**PUR-1270  
ADDENDUM NO. 4  
INVITATION TO BID**

**CONOCOCHEAGUE TREATMENT PLANT ENR UPGRADE**

**DATE: Thursday, May 19, 2016**

POST ANOXIC/ REAERATION TANK PLANS  
 DRAWING NO.: **PM-19A**  
 SHEET NO.: 45 OF 327  
 SP-15-028

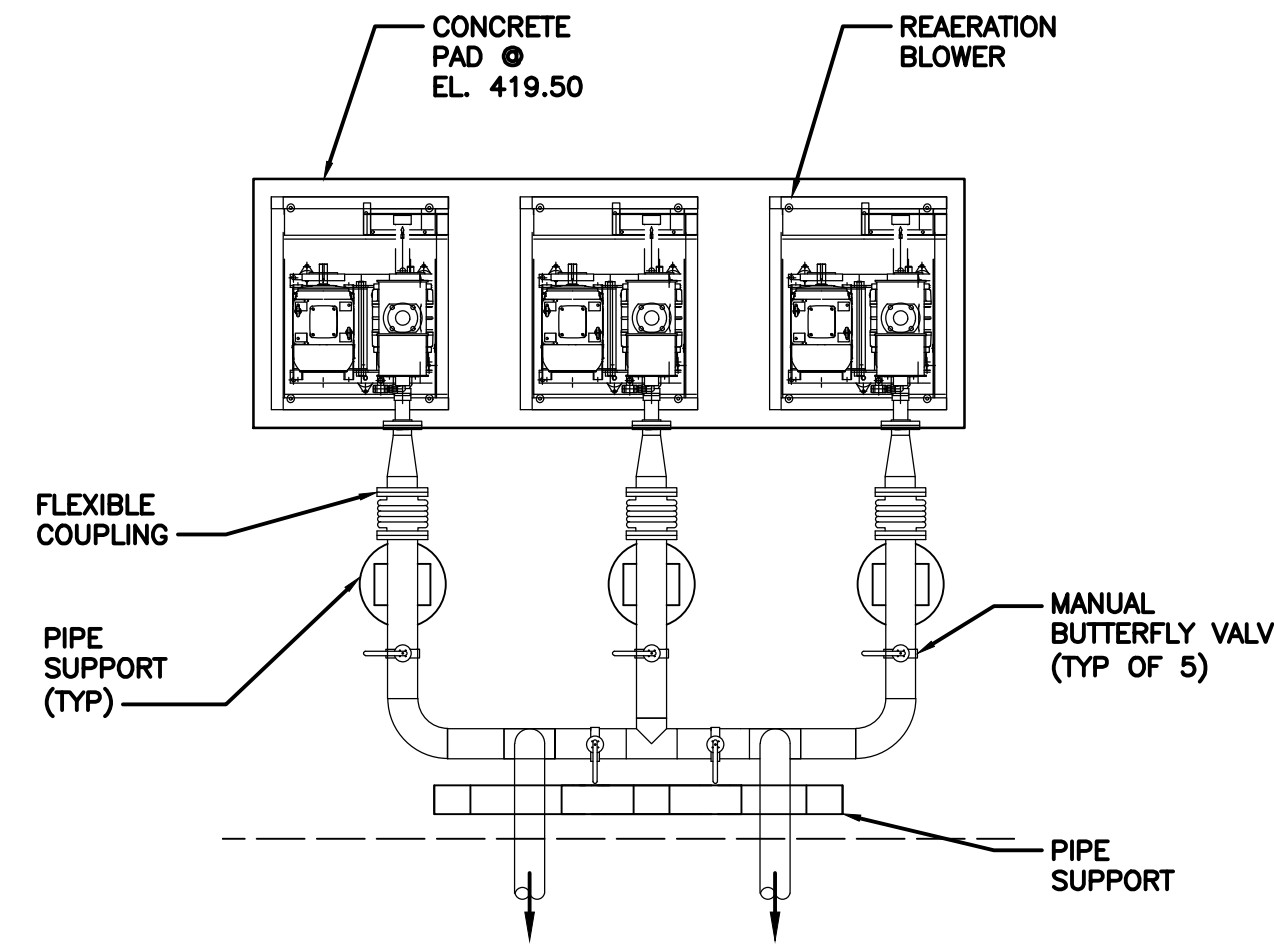
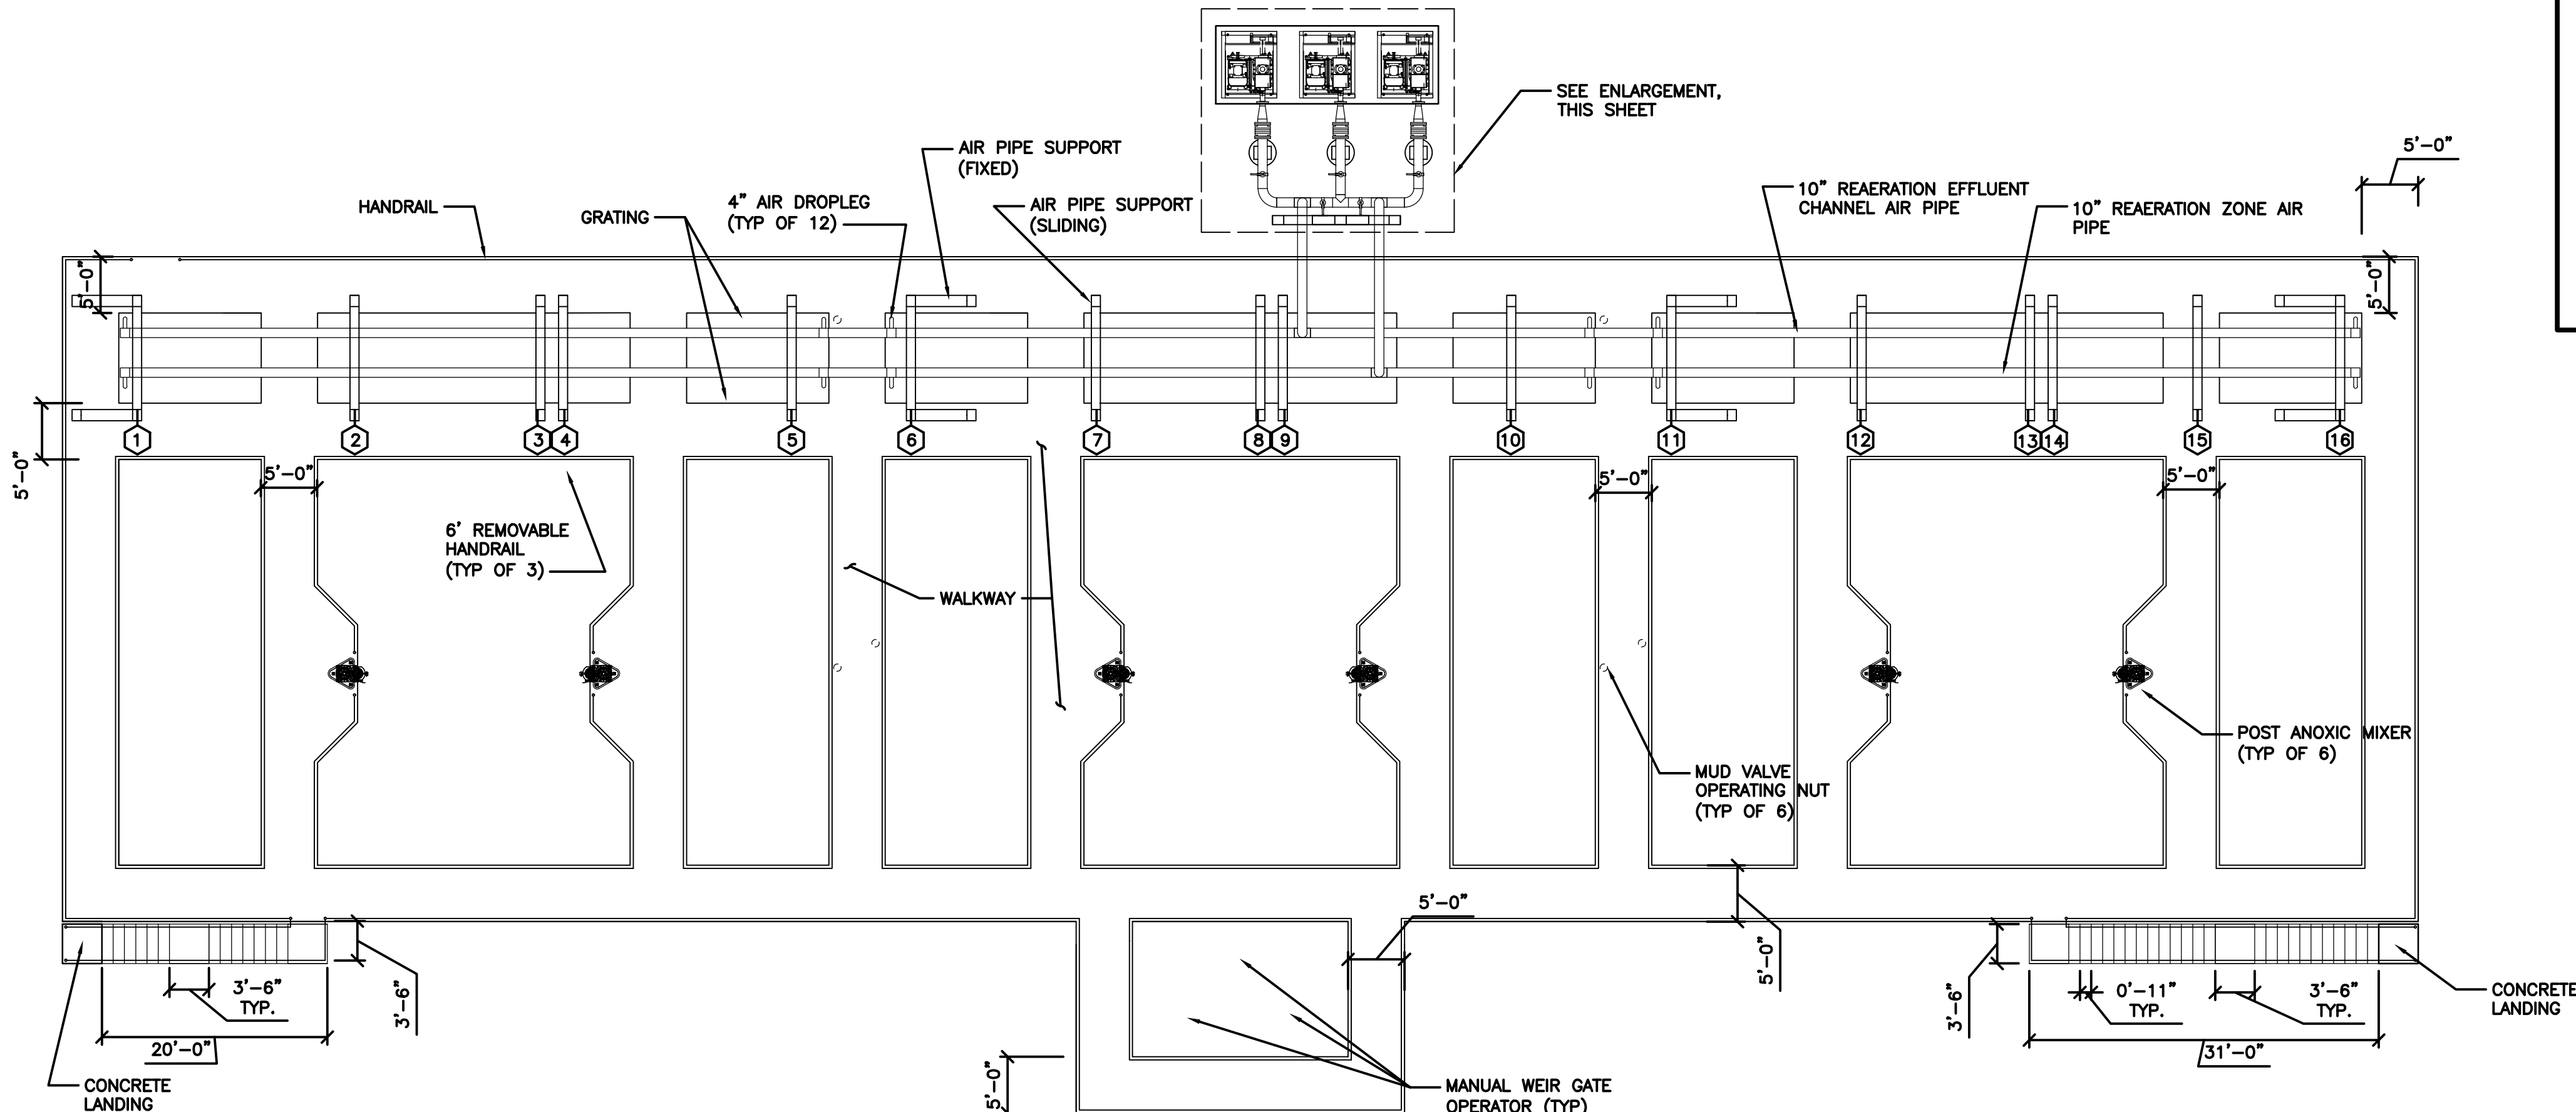
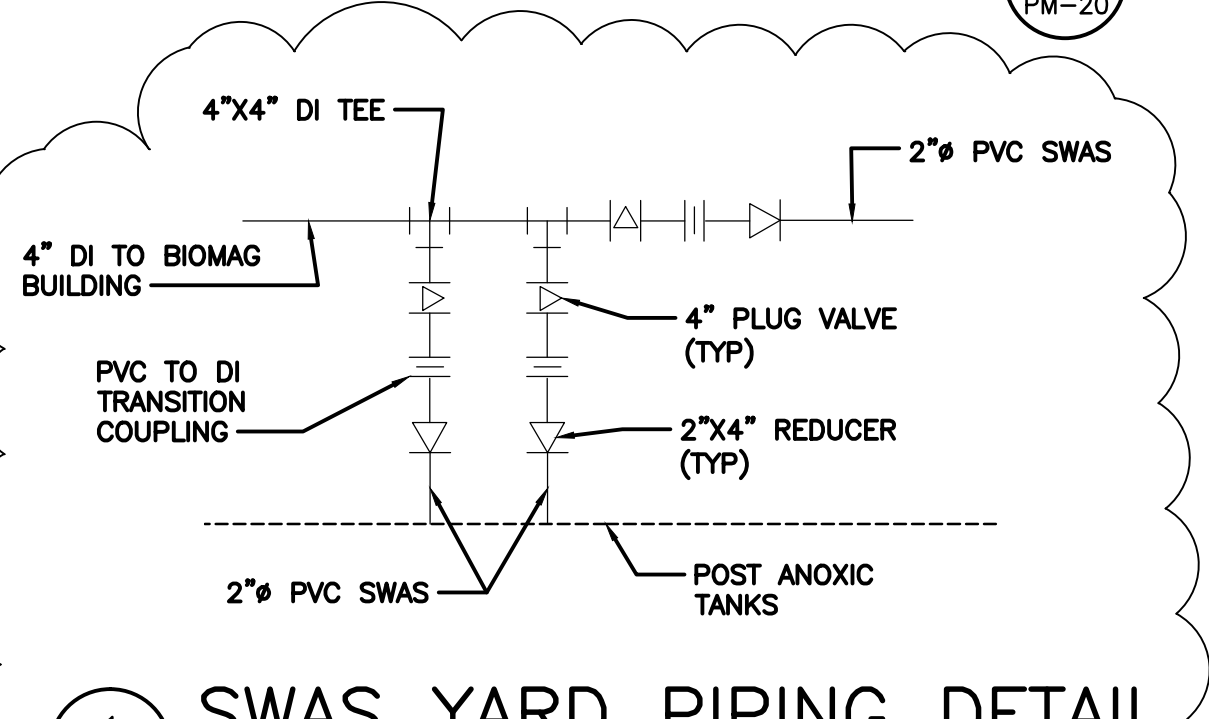
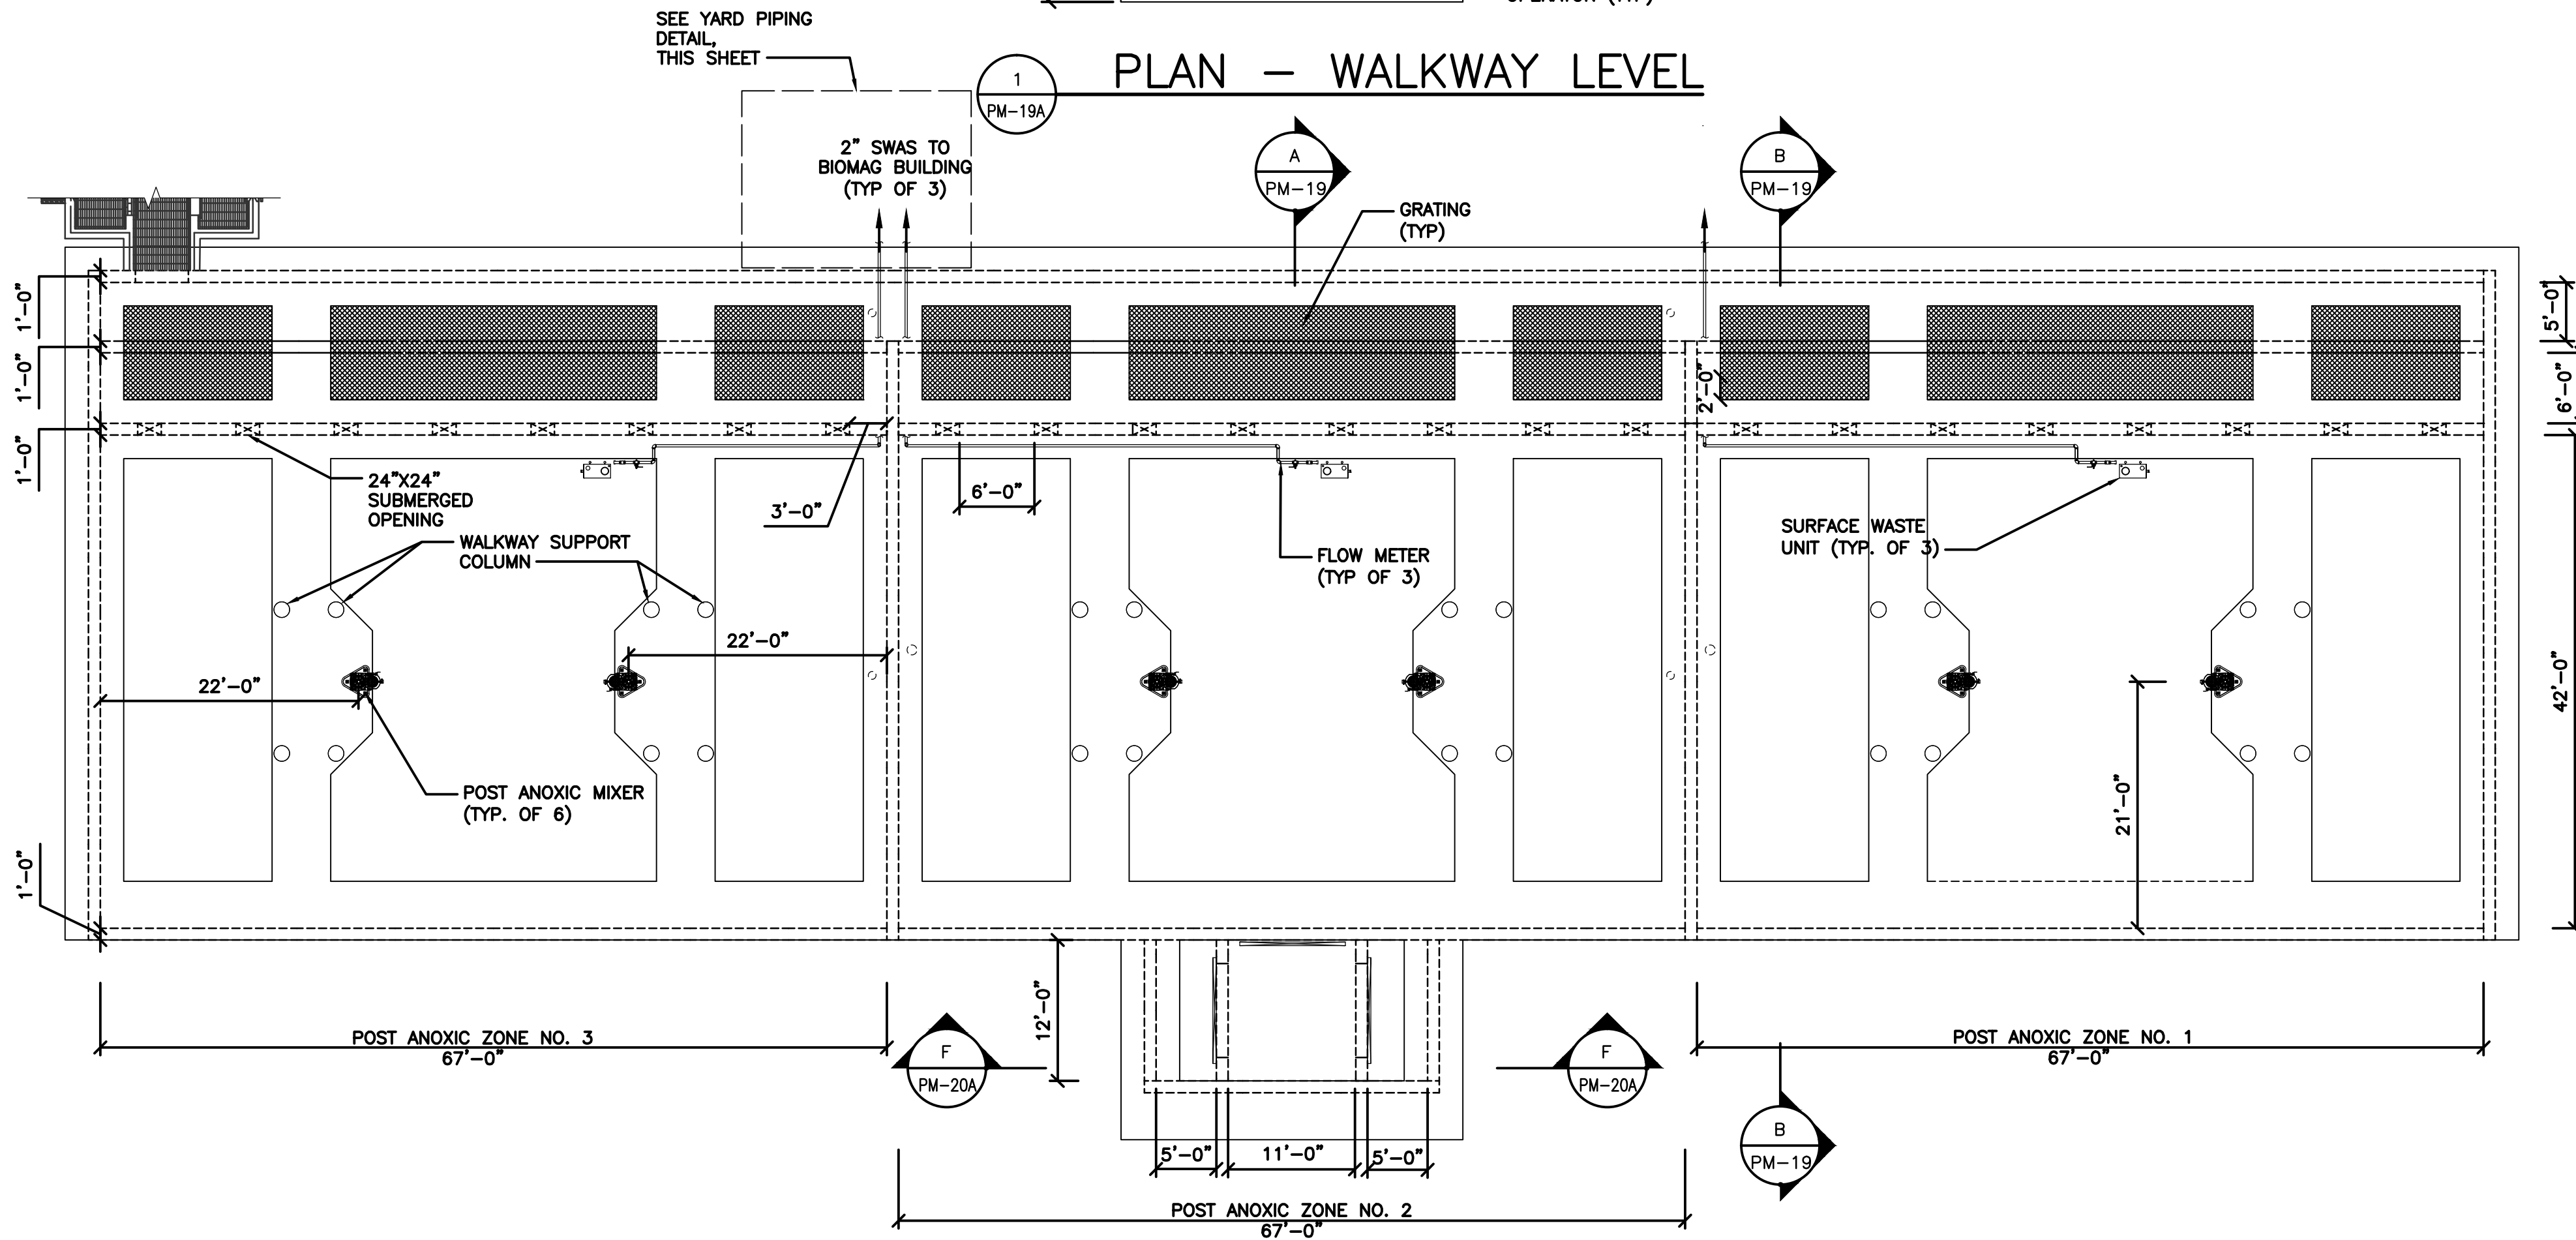
**ITEM NO. 15:** *Inquiry:* The SWAS Line to the Biomag Building is shown on sheet 45 as 2" with no material specified. The yard pipe plan has the line identified as line 132, a 4" DIP line. Where does this the line change from 2" to 4" and what material is the 2" pipe?

**ITEM NO. 17:** *Inquiry:* Yard Pipe Line 132 is scheduled as a 4" Ductile Iron Pipe which runs between the (3) Post Anoxic Tanks & the Bio-Mag Building. On the Post Anoxic Tank process drawings section I/PM-19A shows (3) 2" SWAS lines to Bio-Mag Building. Please clarify.

*Response:* The SWAS 2" discharge pipe shall be PVC (Schedule 80). Once underground outside of the PA Tank the 2" PVC shall transition to 4" DIP. See detail on attached drawing PM-19A.

*Response:* See the response to ITEM NO. 15 in this Addendum.
